Agenda
Village of Arlington Heights
Design Commission
Virtual Meeting

Item: DC#20-055 - 1141 N. Chestnut Ave. - SF/Teardown

STAFF DESIGN COMMISSION REPORT

Item: DC#20-056 - 1145 N. Chestnut Ave. - SF/Teardown

EXTERIOR ELEVATIONS & MATERIALS

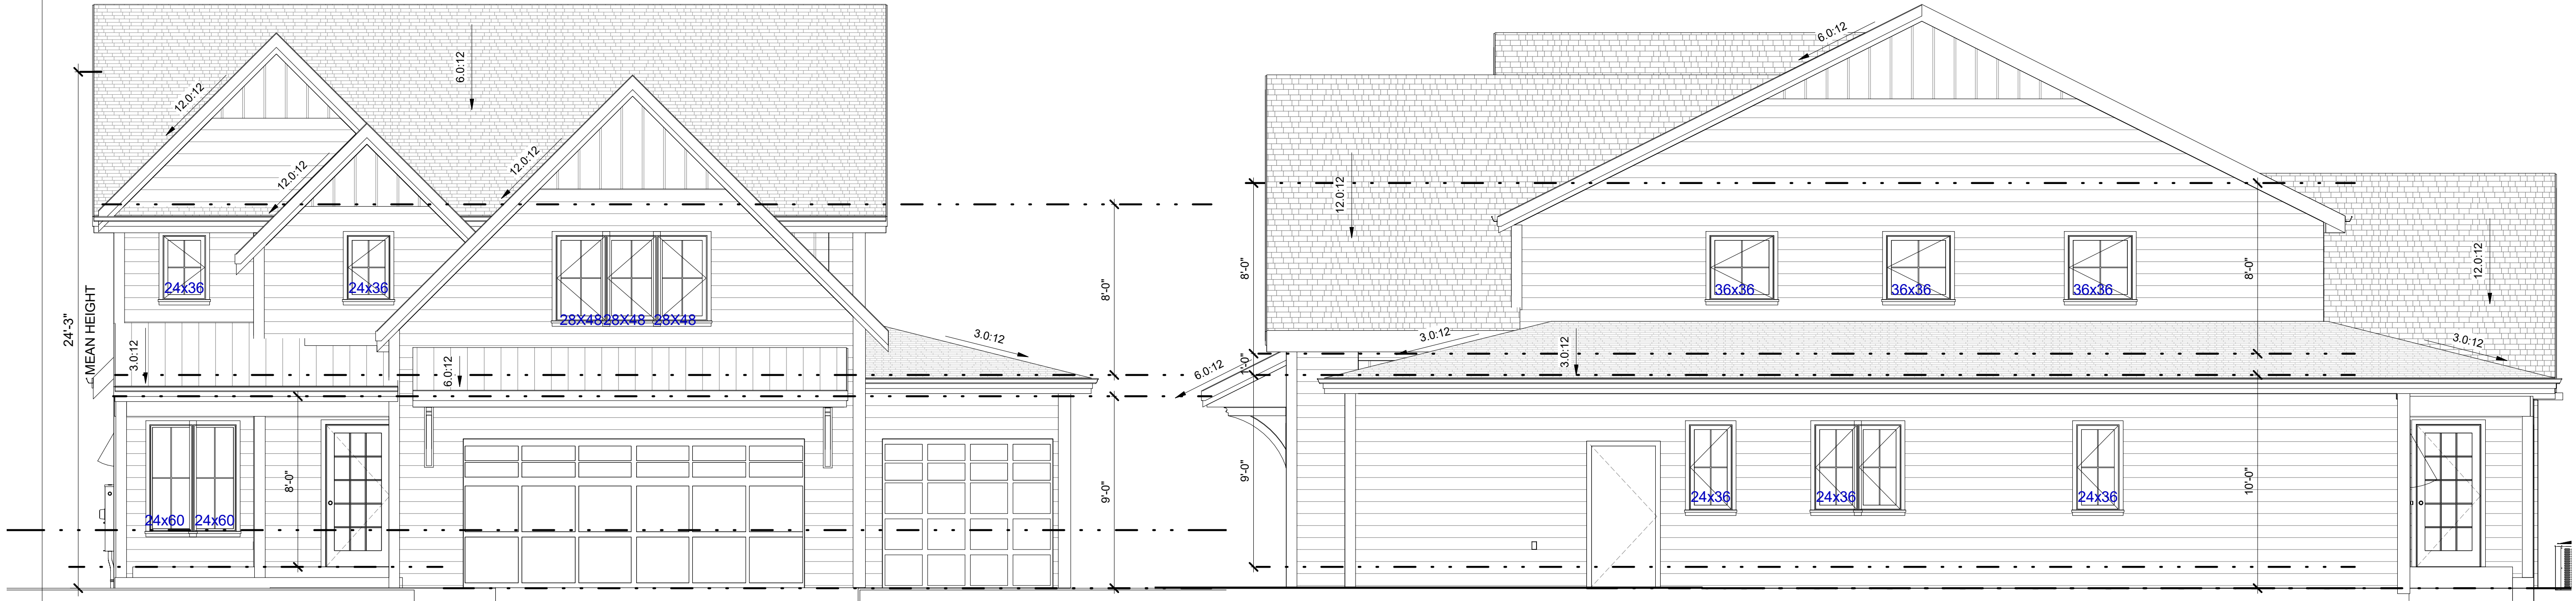
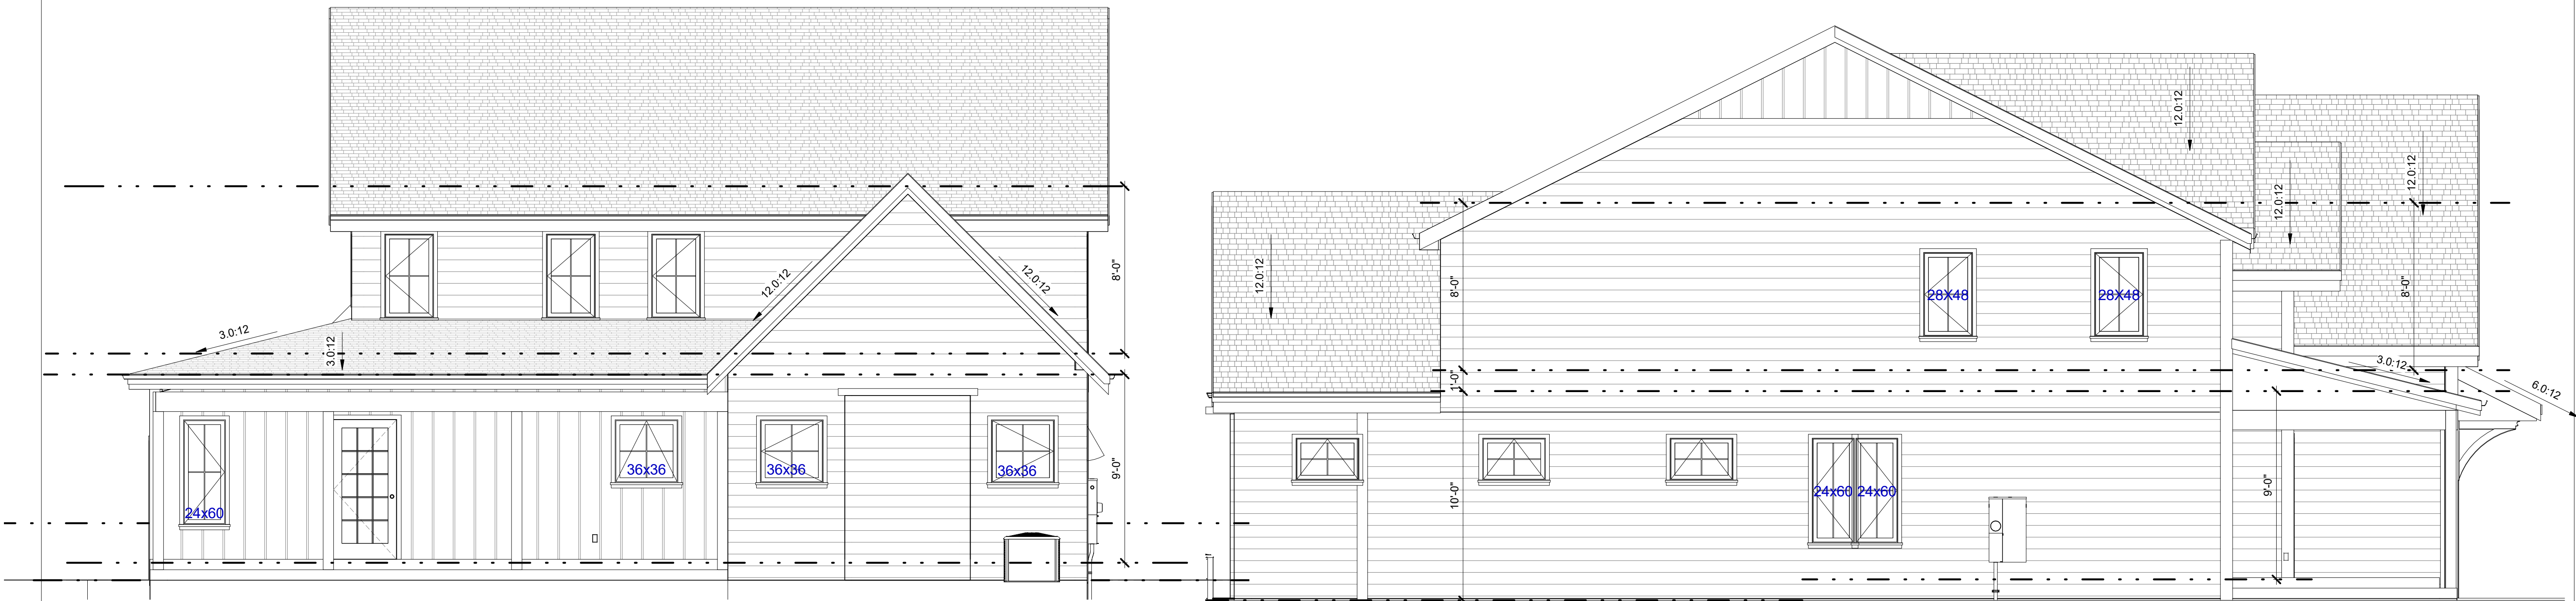
Overall, the proposed design is nicely done in a traditional style that will generally fit well in this location. The single-story front porch, the eave detail above the garage, and the single-story third car garage space help the design to relate and transition to the adjacent single-story house. The all siding exterior has a nice appearance, but all of the houses on this block have some masonry incorporated in the design, which the proposed design lacks.

1. A recommendation to add some masonry accents to the design to better fit with the character of the neighborhood.

SHEET TITLE
NORTH AND WEST ELEVATIONS

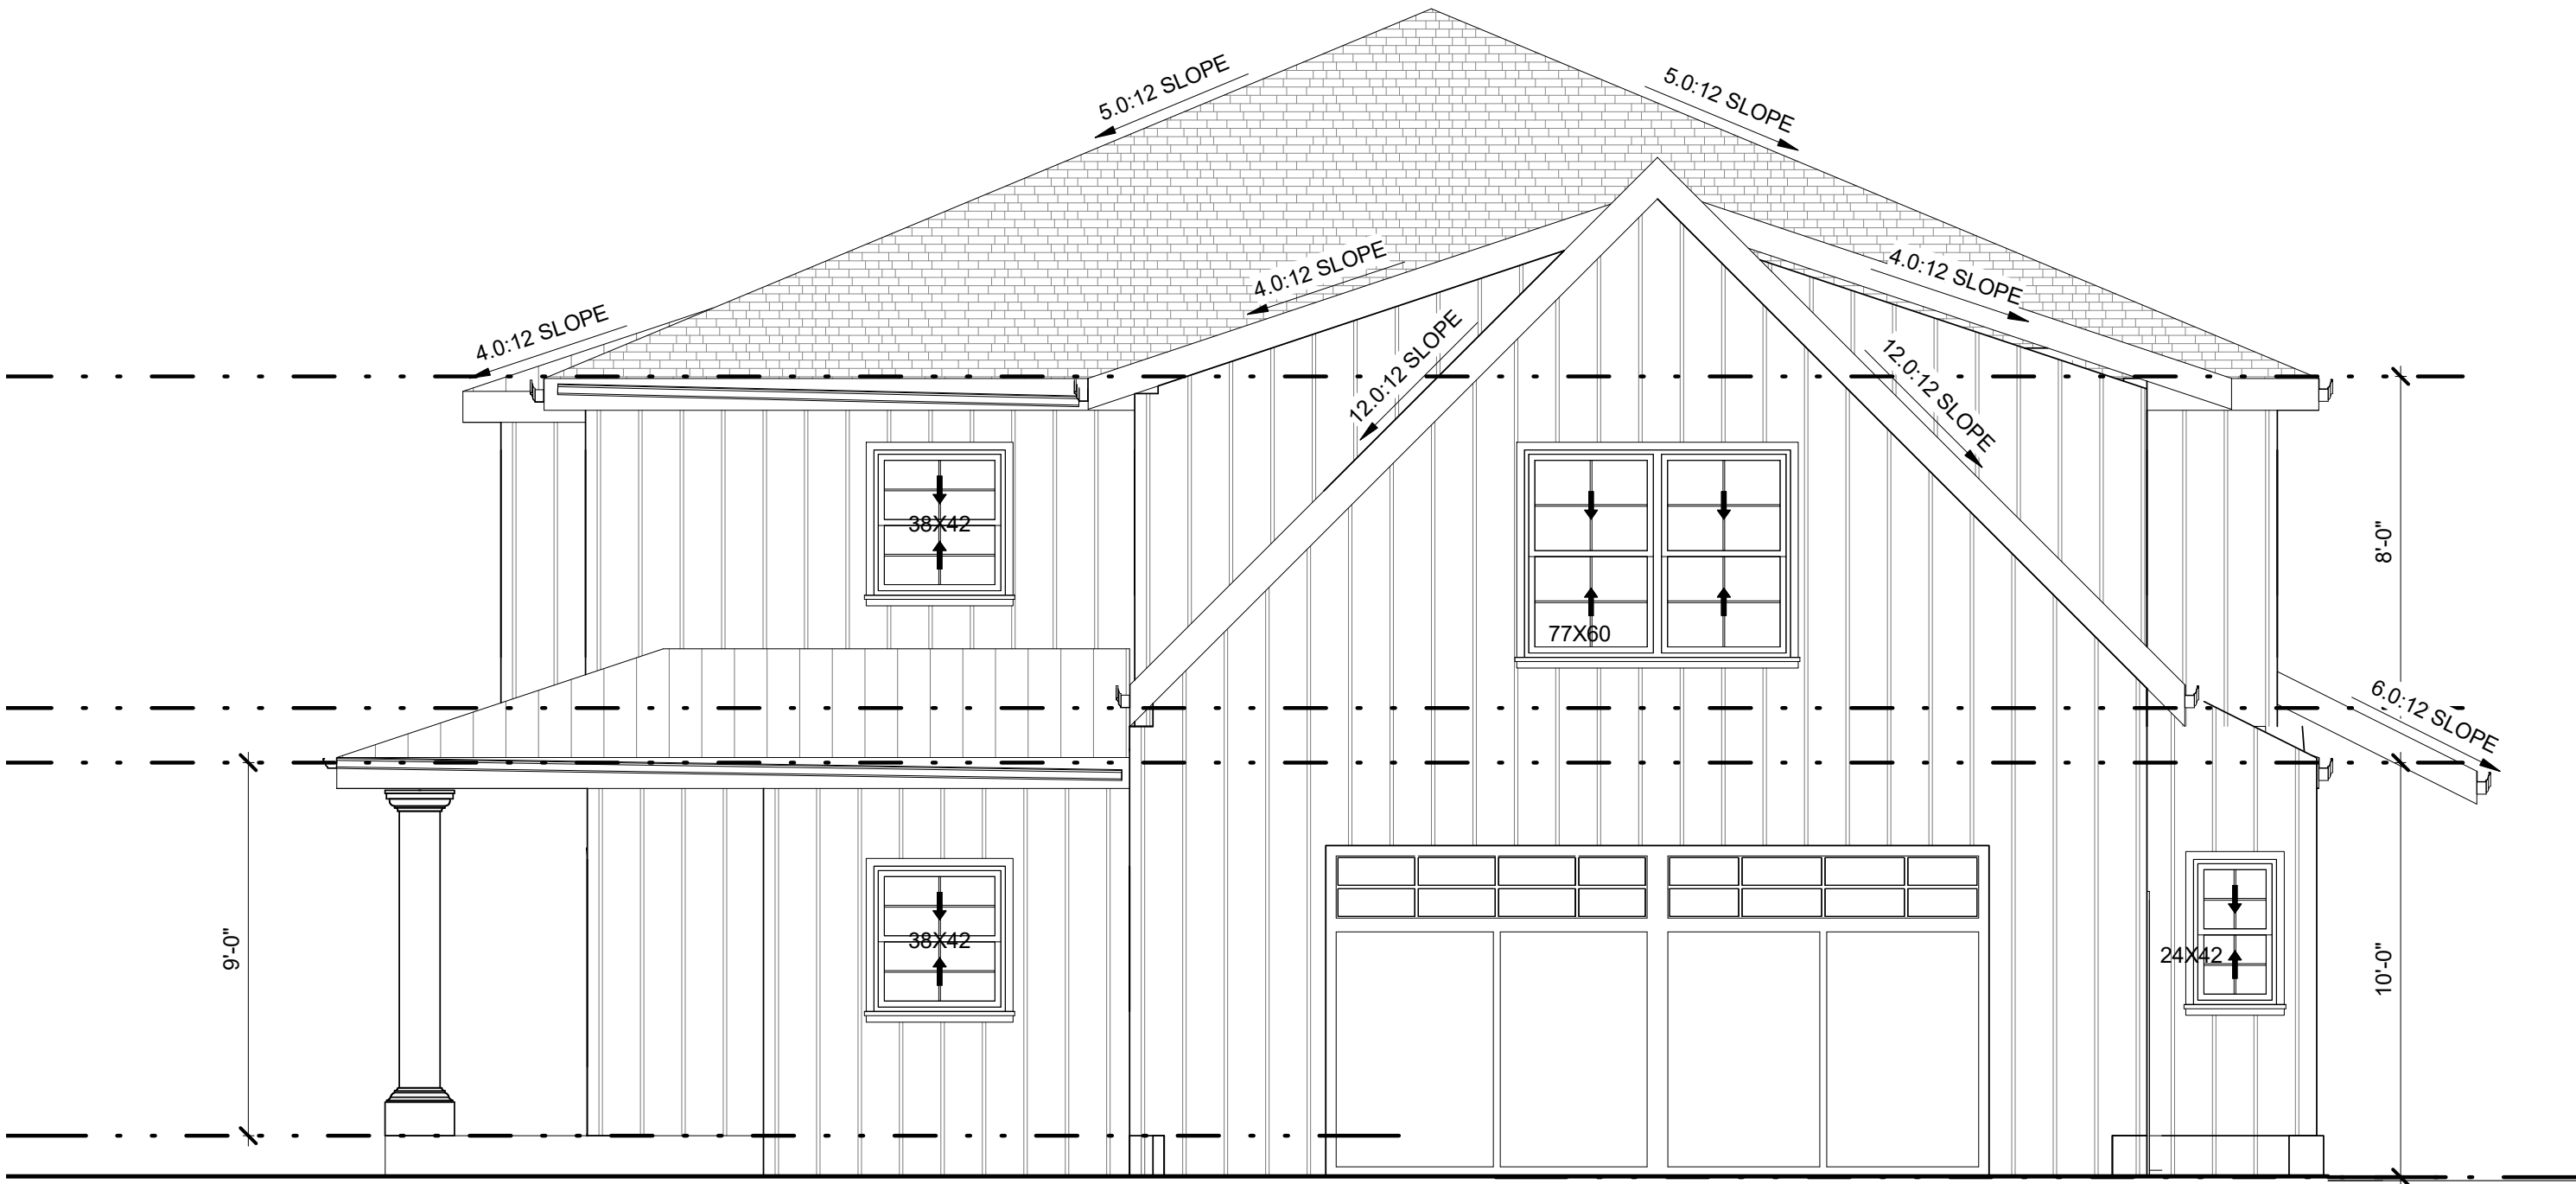
Overall, the proposed design is done in a traditional style that will generally fit well in this location. However, the west elevation facing Chestnut is dominated by the garage, so a revised design is recommended with the garage relocated to the east side of the house, or at least with more living space located towards Chestnut. Additionally, the porch columns on the north (front) elevation are not centered on the symmetrical façade. It is recommended that the depth of the wrap around porch on the east and west be made equal to center the porch columns on the north elevation. Finally, the all siding exterior has a nice appearance, but all of the houses on this block have some masonry incorporated in the design, which the proposed design lacks.

1. A revised design is recommended with the garage relocated to the east side of the house, or at least with more living space located towards Chestnut.

2. It is recommended that the depth of the wrap around porch on the east and west be made equal to center the porch columns on the north elevation.
3. A recommendation to add some masonry accents to the design to better fit with the character of the neighborhood.
